# Dutton & Jett Note Block Diagram -- AMD Brazos 2.0

Quanta Computer Inc.  
PROJECT : LI2A

# LI2A-AMD Schematic EC Tracking Record (Before A stage) 2011.11.10

# LI2A-AMD Schematic EC Tracking Record (After A stage) 2011.12.19

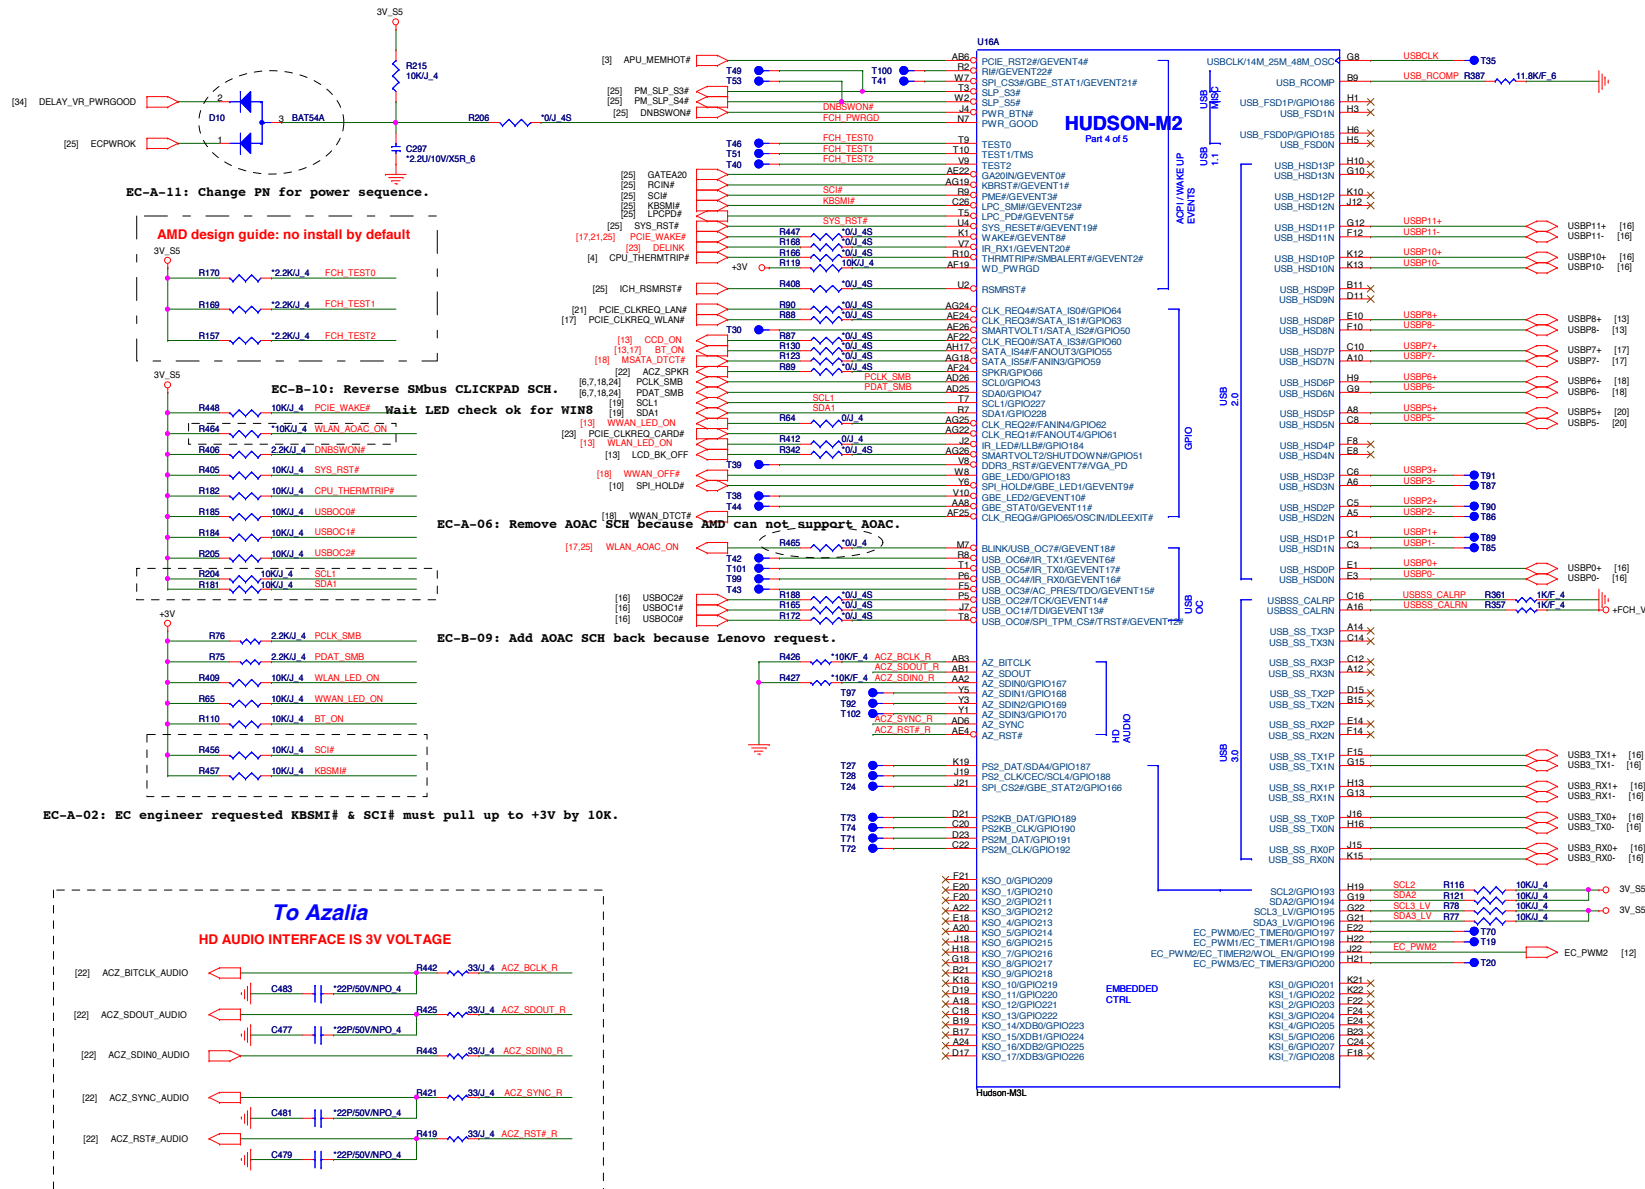
EC-A-20: AMD Check list error. This change made HDMI Function 0

EC-A-20: AMD Check list error. This change made HDMI Function OK.  
Add: CS21002FB24 - R33.  
Remove: CS21002FB24 - R30.

**CCD+LOGO+WLAN LED CONN**

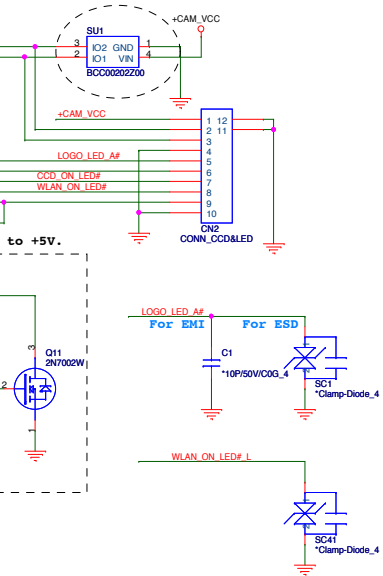
EC-A-22: EE request in order LED action error by DIS\_BT

EC-C-01: Drop CCD Led relation BOM.

EC-C-10: Remove CML1 & R5 & R8 in order to place R483 & R484

EC-A-21: ESD request.

EC-A-19: Lenovo modify LED brightness.

EC-A-22: EE request in order LED action error by DIS\_BT  
Remove: BAM70020004 - Q25.

EC-C-01: Drop CCD Led relation BOM.

EC-C-10: Remove CML1 & R5 & R8 in order to place R483 & R484

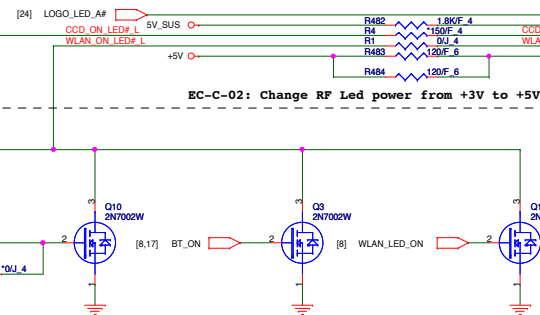
**EC-C-02: Change RF Led power from +3V to +5V.**

EC-23: add WWAN, WLAN, BT LED SCH to match Jett spec

EC-C-02: Change RF Led power from +3V to +5V.

### ***CAMERA VCC Control***

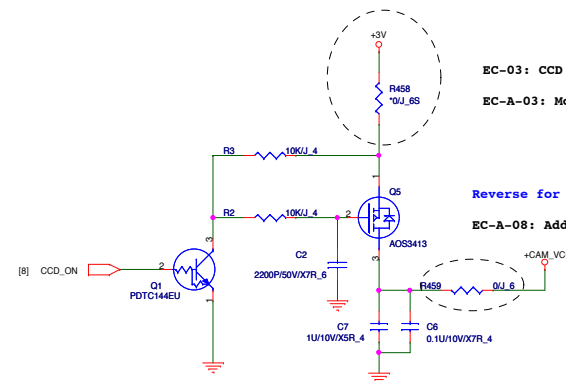
**EC-03: CCD power changes from +5V to +3V**

EC-A-03: Modify CCD power source width.

EC-A-03: Modify CCD power source width.  
Add: CS00003J951 - R458  
Remove: CS00002JB38 - R11 & \*R12

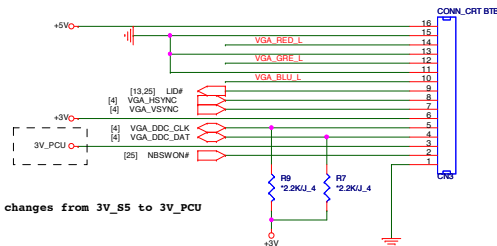
EC-A-08: Add 0 ohm to CCD power.

EC-A-08: Add 0 ohm to CCD power.  
Add: CS00003J951 - R459

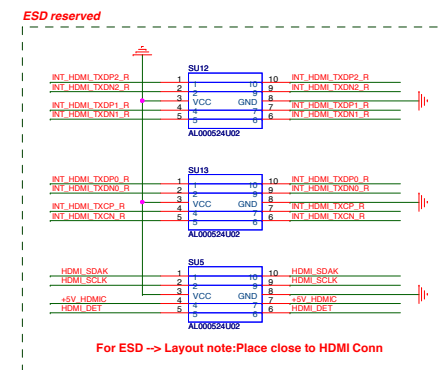
EC-19: Hall IC power changes from 3V\_S5 to 3V\_PCU

## HDMI CONN

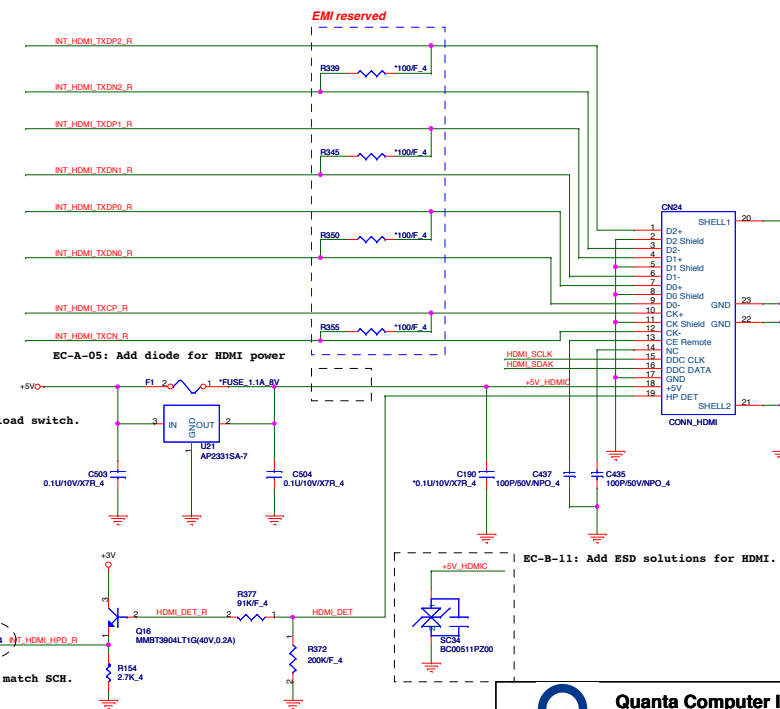
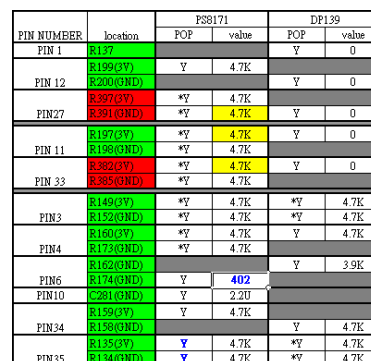
EC-02: Remove AMD HDMI related components

# SATA HDD CONN

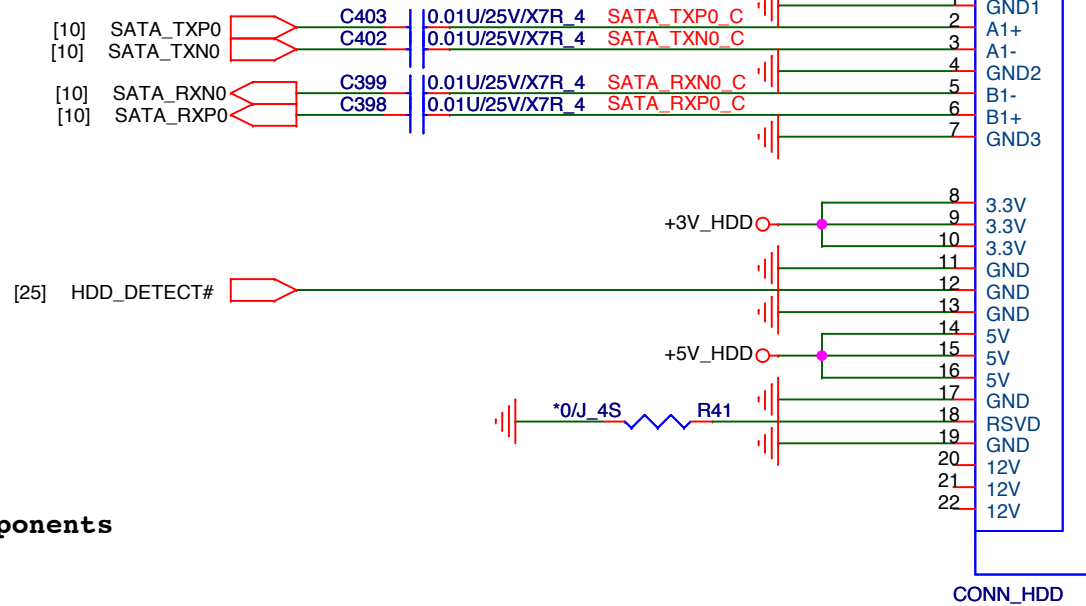
EC-01: Remove SATA redriver & other components

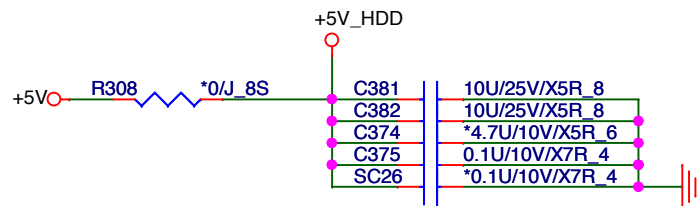
EC-16: Reserved ESD components  
by ESD engineer's suggestions

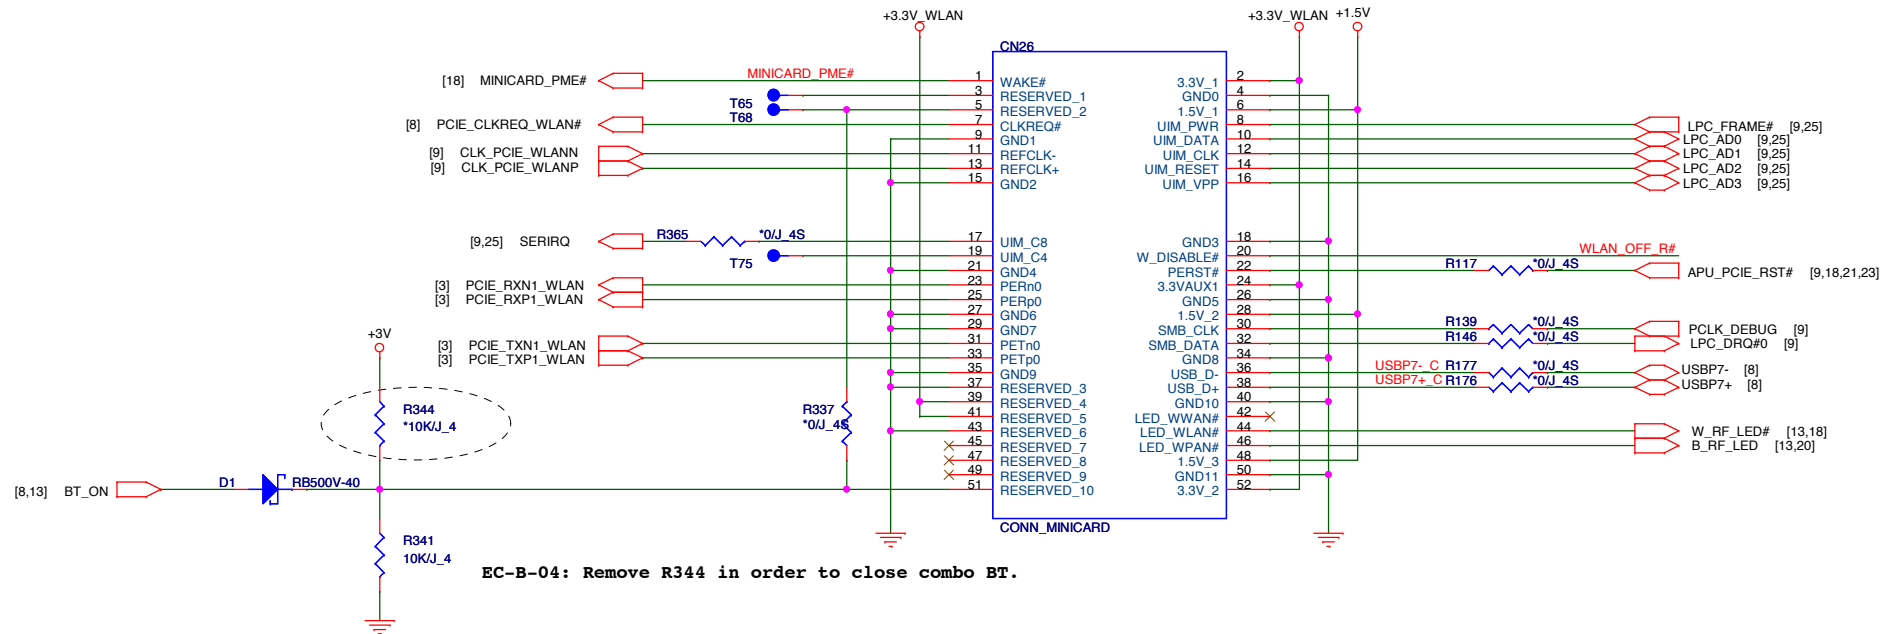
EC-A-06: Remove AOAC SCH because AMD can not support AOAC.

EC-A-06: Remove AOAC SCH because AMD can not support AOAC.  
Remove: CS00002JB38 - R167

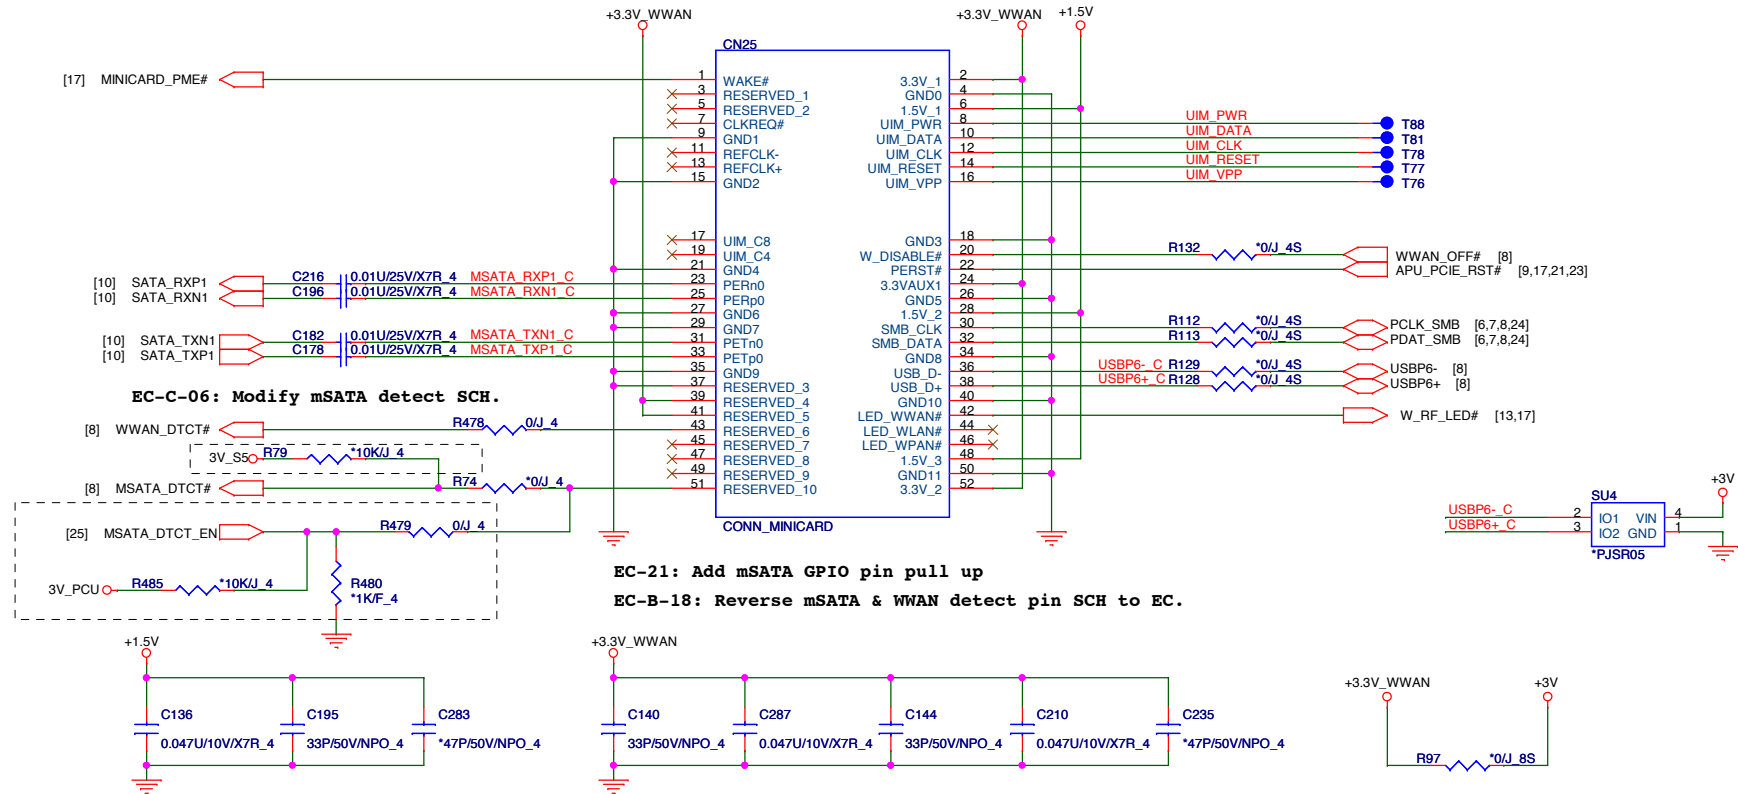
EC-B-09: Add AOAC SCH back because Lenovo request.

EC-B-09: Add AOAC SCH back because Lenovo request. Reverse AOAC & pcie\_wake to EC.

## TRACK POINT

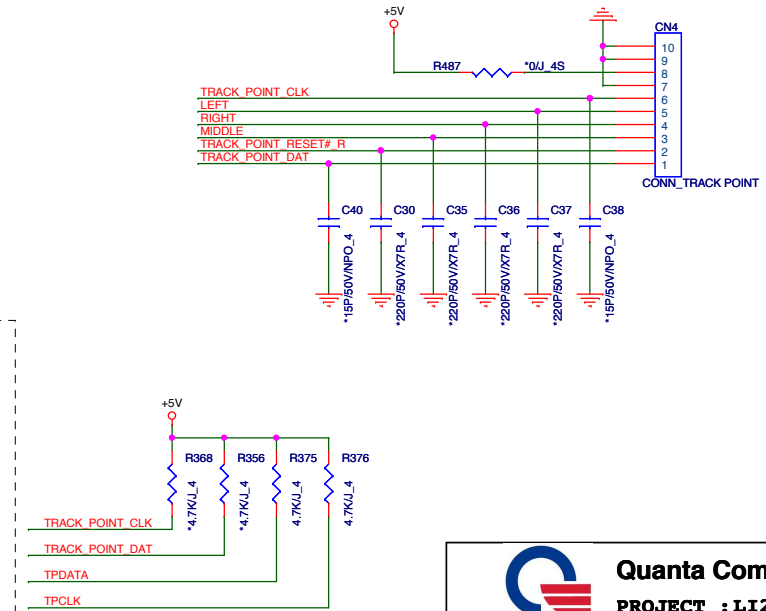
EC-B-10: Reverse Smbus CLICKPAD SCH.

EC-B-10: Reverse SMBus CLICKPAD SCH.

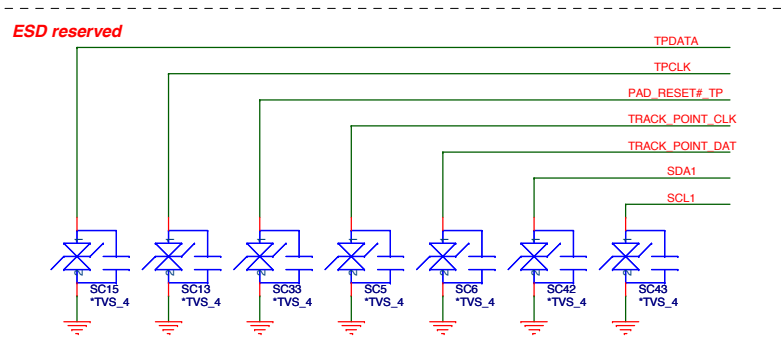
EC-08: Reserved ESD components by ESD engineer's suggestions

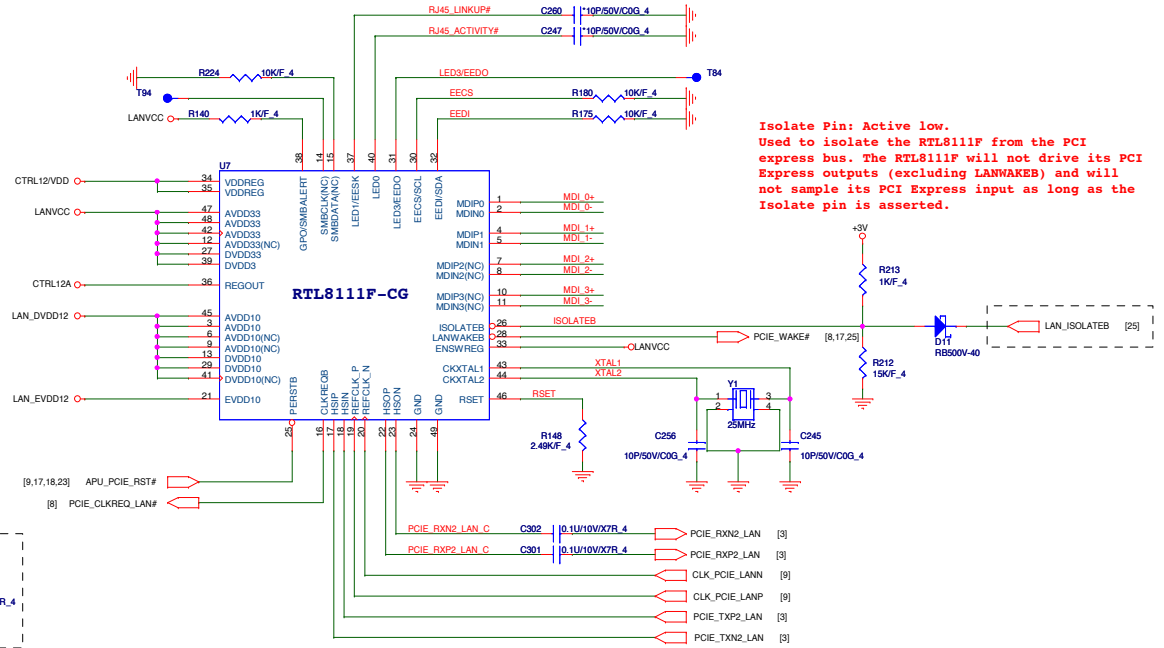
EC-A-09: Add 1M ohm (1206) & reserve 1M ohm (0603) to pass Hi-Pot & ESD test.

EC-A-09: Add 1M ohm (0603) & reserve 1M ohm (1206) to pass Hi-Pot & ESD test.  
Add: CS51003F934 - R460  
Remove: CS51003F934 - R231

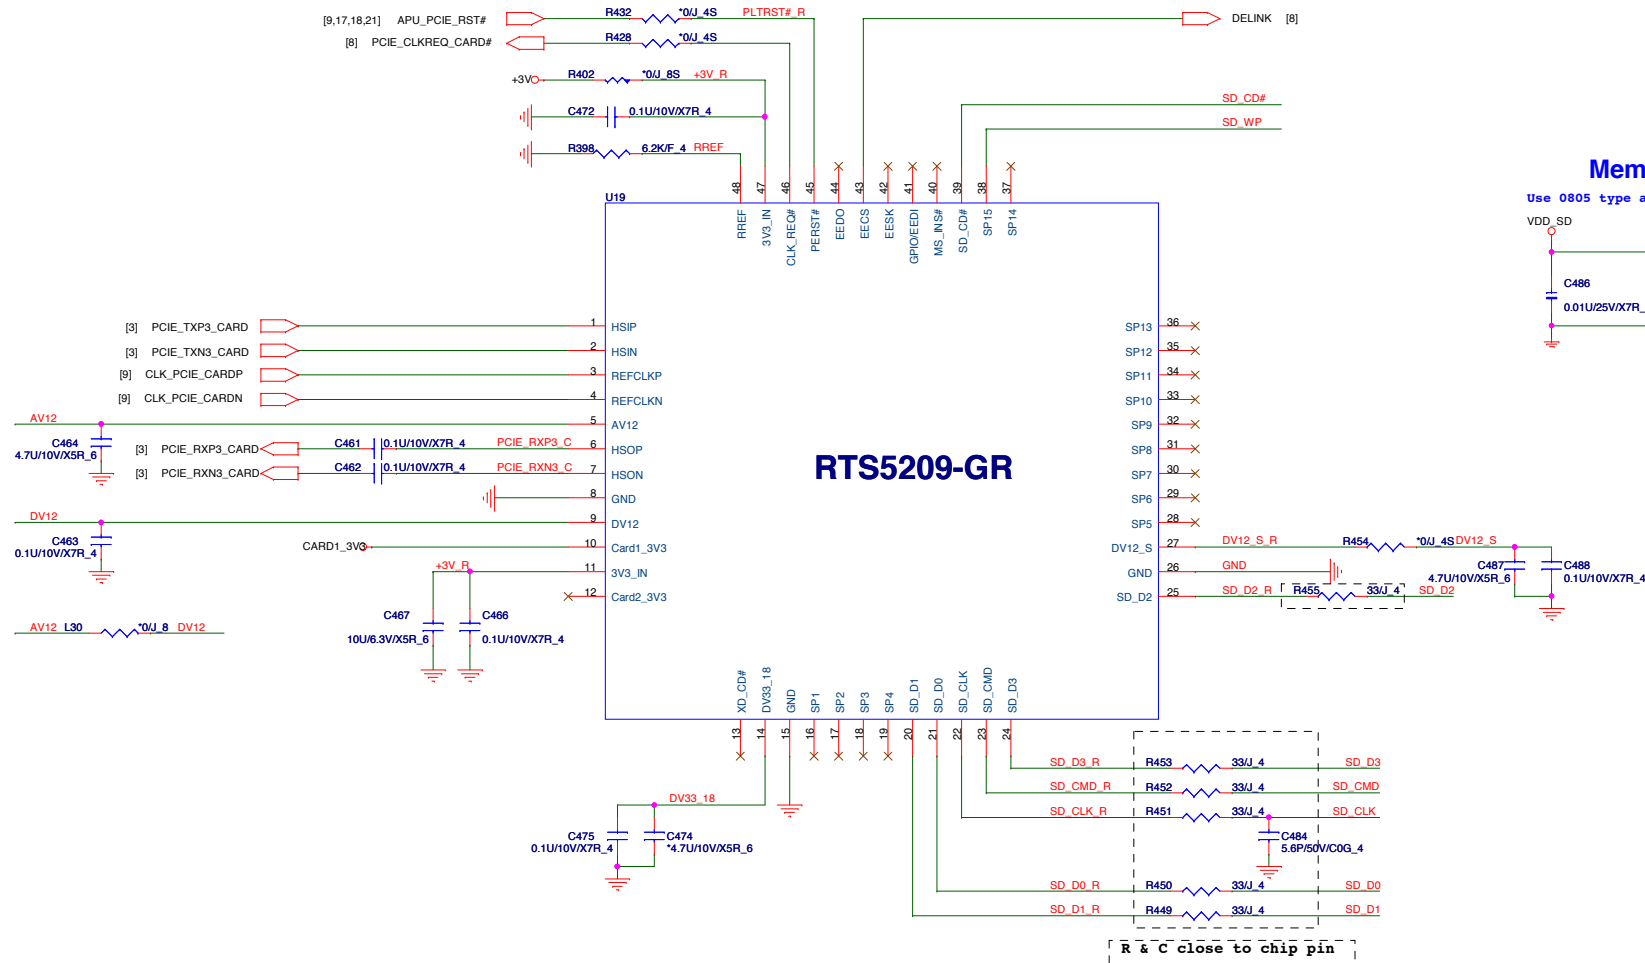
EC-08: Reserved ESD components by ESD engineer's suggestions

## 4 IN 1 CARD READER SD/SDHC/SDXC/MMC

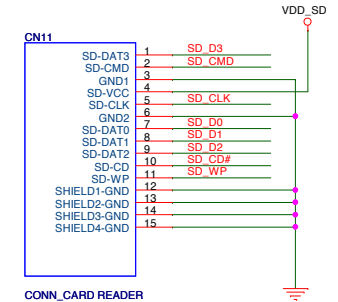
It is recommended that mismatch trace length between CLK and DATA trace is 100 mils with maximum  
EC-A-18: Add 33 ohm in card reader related SCH to match vendor suggestions & EMI test.

EC-A-18: Add 33 ohm in card reader related SCH to match vendor suggestions & EMI test.  
Add: CH-5606TB01 - C484  
Change: from CS00002JB38 to CS03302JB29 - R449, R450, R451, R452, R453, R455.

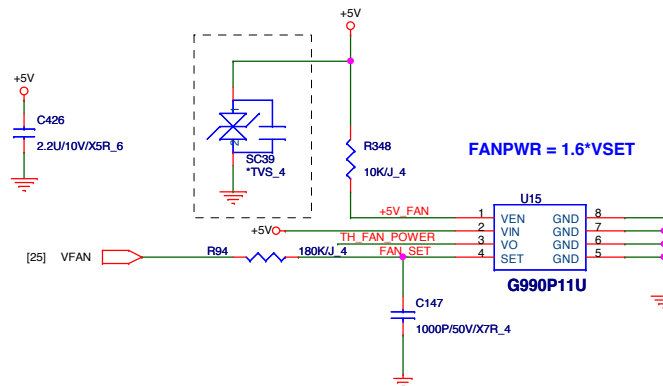
EC-B-15: Reverse ESD solutions for USB3.0.

EC-17: Reserved ESD components by ESD engineer's suggestions

EC-B-15: Reverse ESD solutions for USB3.0.

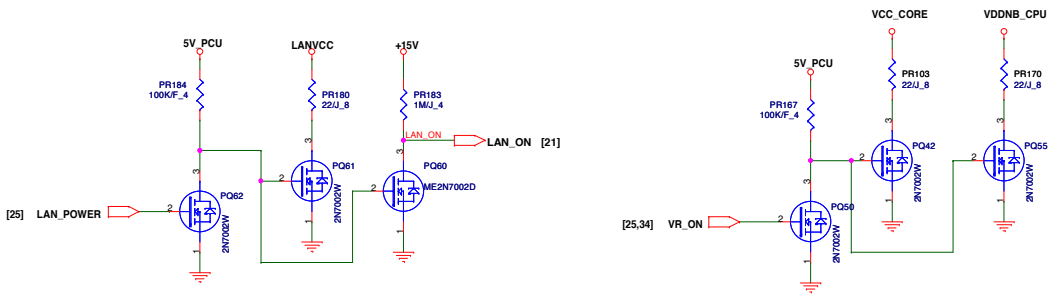
EC-11: Modify PTC NAME: PR9178(1.1V\_S5), PR9179(5V\_PCU), PR9180(3V\_PCU)PR9181(+1.05V), PR9184(VDD\_NBCPU), PR9189(VIN), PR9194(ACIN), PR9193(CHARHER), PR9192(Battery IN), PR9191(VCC\_CORE), PR9196(1.5V\_SUS).
